Project: **Barns Court, Copthorne** Job No.: **10427658**

Subject: **Drainage Technical Note for Phase 1B.**

The purpose of this Technical Note is to address the comments received by Mid Sussex District Council Flood Risk and Drainage Team related to the planning application DM/24/2622.

Figure 1 – Flood zone mapping

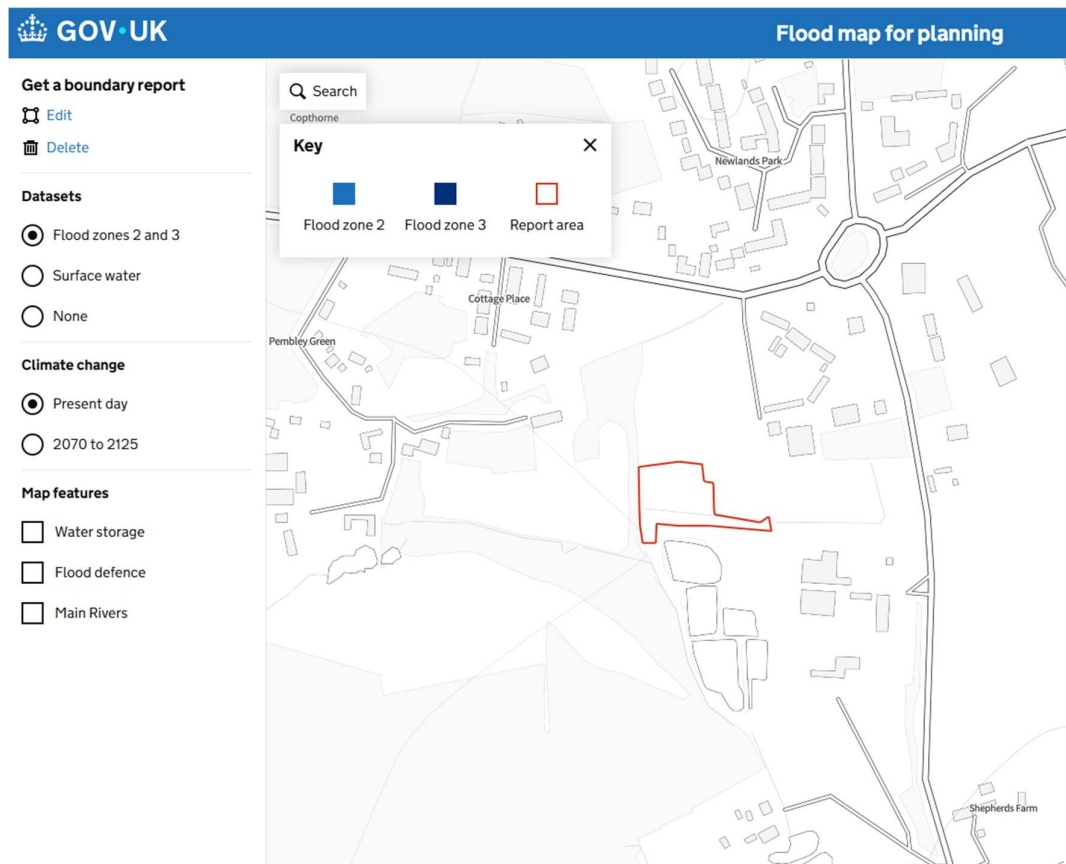
- ***Overlay required:*** The applicant must overlay the proposed built footprint onto the updated EA surface water flood risk mapping.
- ***Demonstration needed:*** Evidence that no increase in built footprint or land raising occurs within:
 - *Flood Zone 3b (functional floodplain),*
 - *The 1:100 year + climate change extent.*
- ***Flow path preservation:*** Evidence that:
 - *The natural surface water flow routes across the site (especially east to west) are preserved, or*
 - *Suitable alternative routes are provided if blocked by the development.*
- ***Ditch connectivity:*** Demonstrate the onward connectivity of the existing ditch on site and how flow will be managed if the ditch is removed.

Figure 1 above shows that the site is not located in a flood zone 3 area and the latest Level 2 SFRA by Mid Sussex District Council does not indicate that the site is located within the functional floodplain. Class B1c (now Class E) is classified as less vulnerable, with flood resilience measure easily incorporated if required, although it appears on the latest maps this will not be required. This class of building is easily returned to a functional state following a flood event however as shown above this appears a very low risk.

10427658 BARNS COURT
ONWARD FLOW PATHS

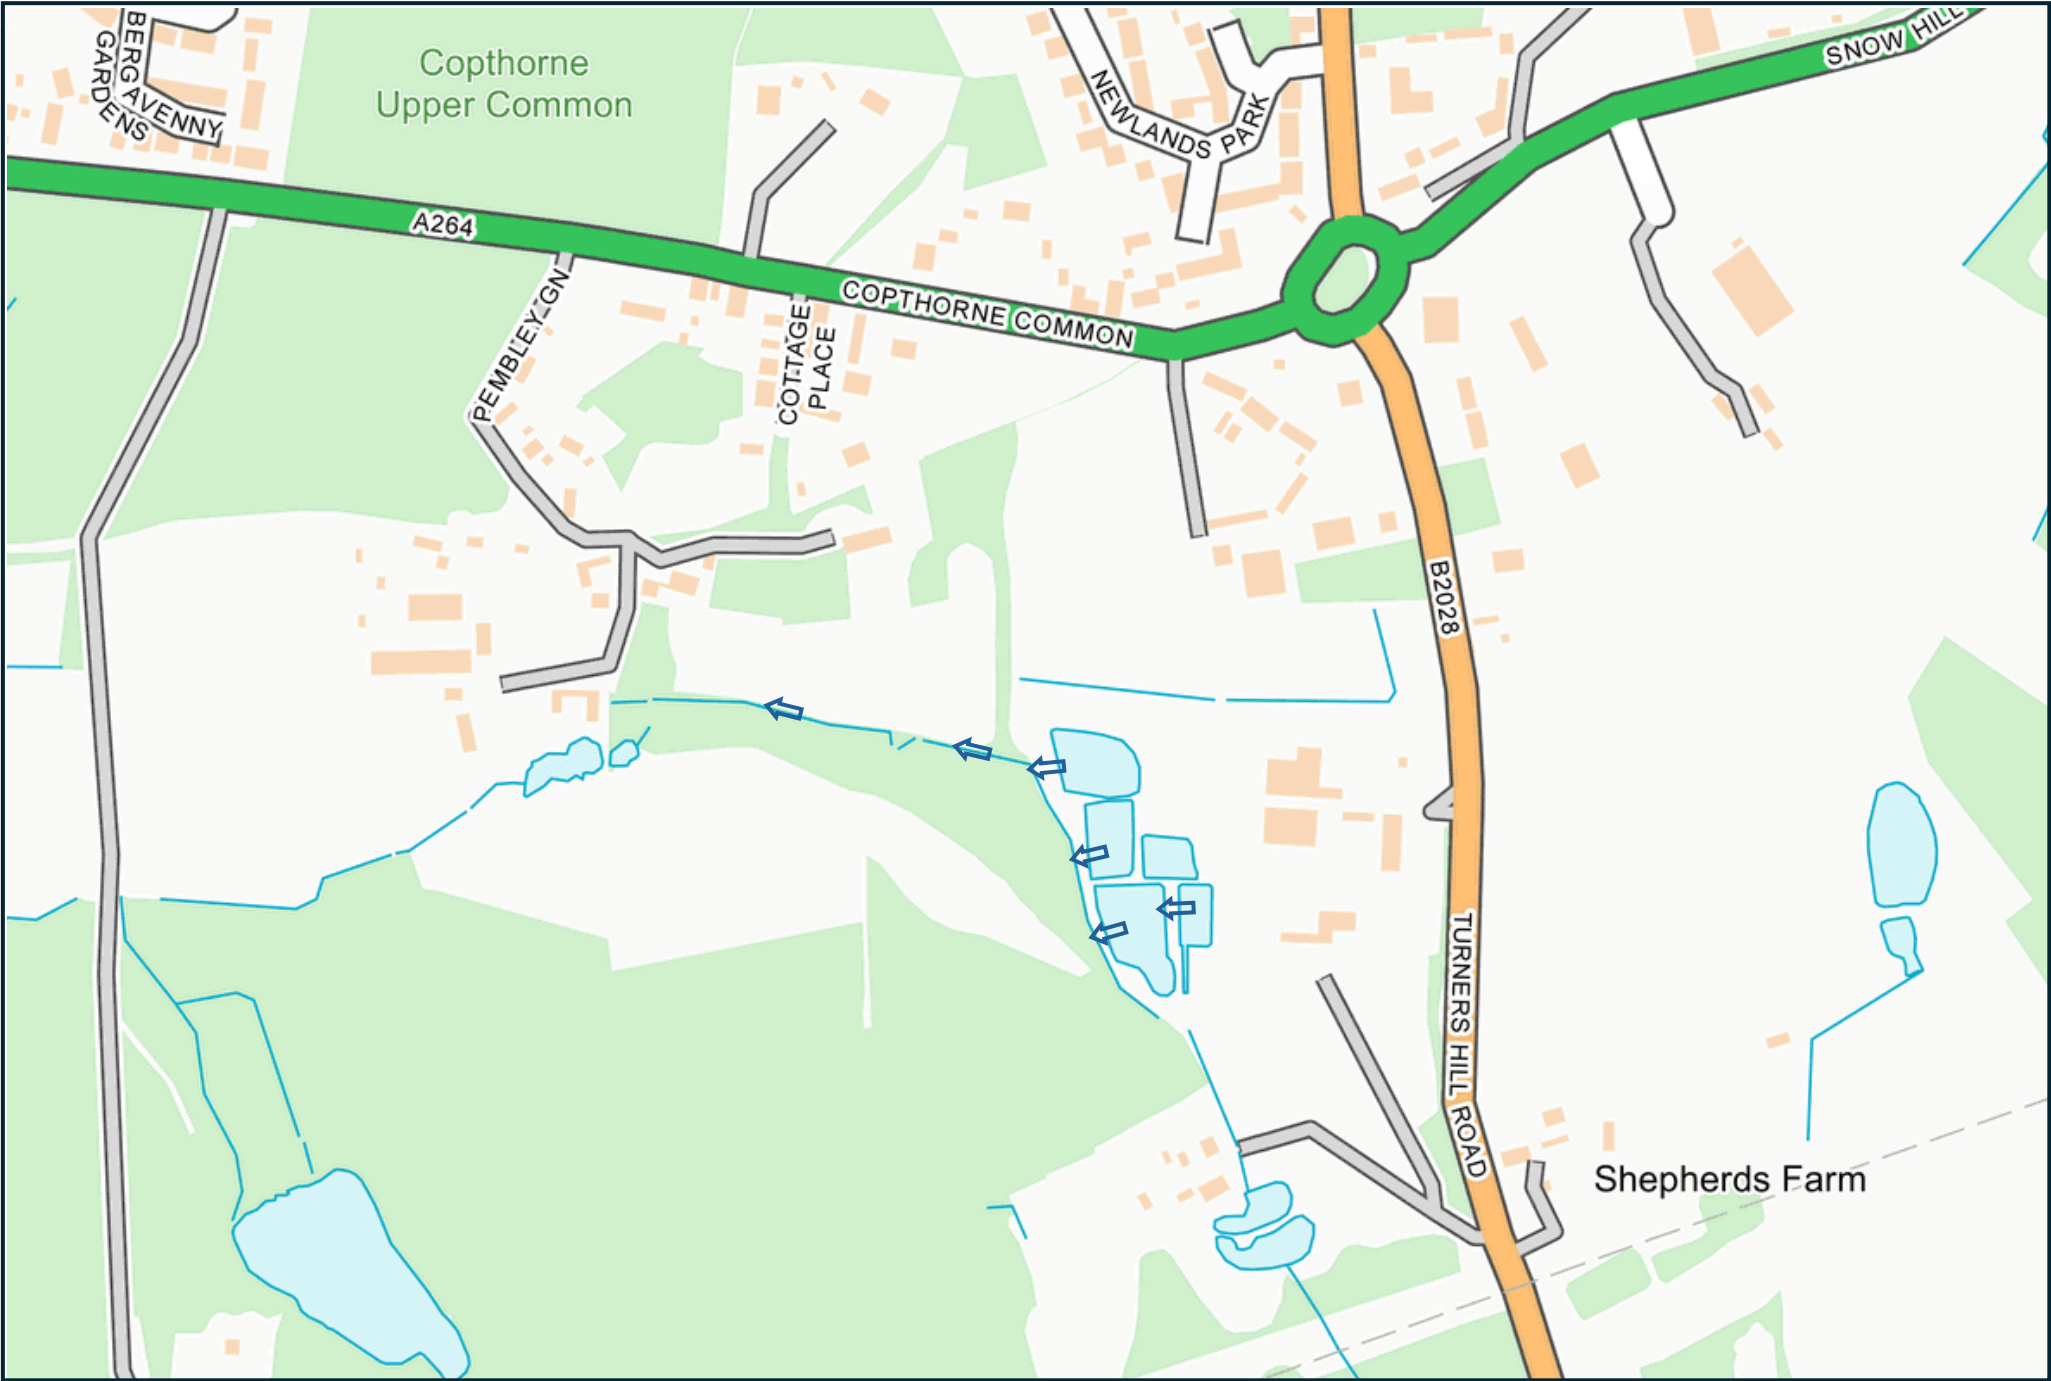
- ***Climate change consideration:*** Confirm that the drainage system accounts for latest climate change allowances from EA (e.g., 1:100-year + latest CC).
- ***Outfall/ponds:*** Provide:
 - *Plans showing wider connectivity of ponds (to show onward flow), or*
 - *Infiltration testing results demonstrating adequate pond half-drain times*

There may be a natural flow path to the north of the site, but outside of the parking area and building footprint, the levels are anticipated to remain at exiting levels, therefore there is no change to the existing condition. The natural flow of the ponds located to the south of the site are shown in Appendix B. It is anticipated that the south north oriented ditch to the west of these ponds receive outflows from them and then are directed westwards via the regional ditch network towards Copthorne.
